RIVERSIDE HOSPITAL 1ST ADDITION

WICHITA, KANSAS

Re: S/D 88-96 - RIVERSIDE HOSPITAL ADDITION, West of Maize
Road, approx. 1/4 mile south of Central

CASE NUMBER: S/D 88-96 RIVERSIDE HOSPITAL 1ST ADDITION

FINAL PLAT

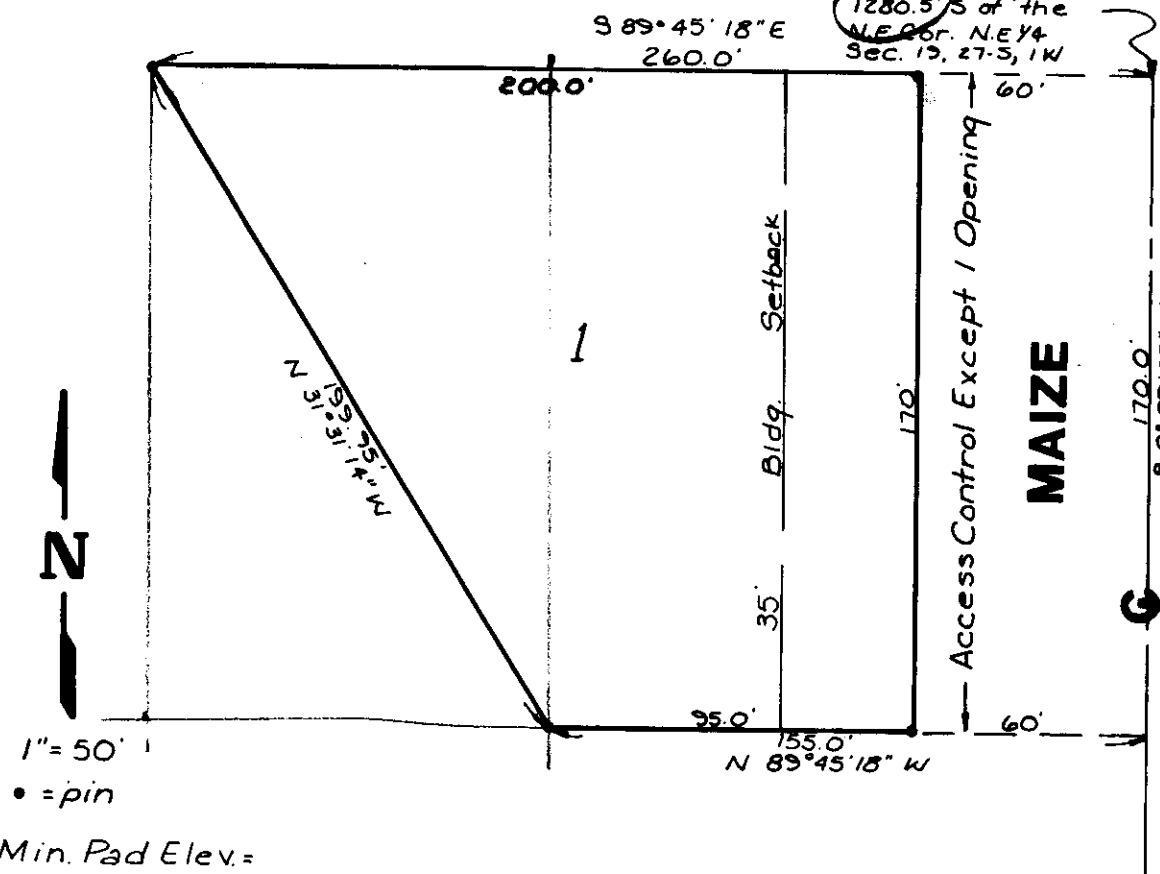
- A. The applicant shall either guarantee the extension of sanitary sewer or obtain the permission of Sewer Maintenance to connect to the existing sanitary sewer manhole within street right-of-way.

- B. The applicant shall guarantee a decel lane adjacent to this plat, along Maize Road. This guarantee will be held and activated only if traffic conditions at this site warrant the improvement.

- D. Prior to this plat being scheduled for City Council review, the applicant shall submit to City Engineering for approval, a revised drainage plan.
- E. As this property is establishing minimum building pad elevations, the face of the plat shall reference the location and elevation of permanent on-site and off-site benchmarks. Section 5-402(N). The minimum building pad elevation for this plat shall be shown as 137.6 City Datum. This elevation shall also be indicated in Mean Sea Level.

- F. The final plat tracing shall indicate a 10-foot building setback from the west property line.
- G. As requested by K.G. & E., the final plat tracing shall indicate a 10-foot utility easement along the north line of the plat.

- J. Perimeter closure computations shall be submitted with the final plat tracing. Section 5-101(c).
- K. Recording of the plat within 30 days after approval by the City Council.
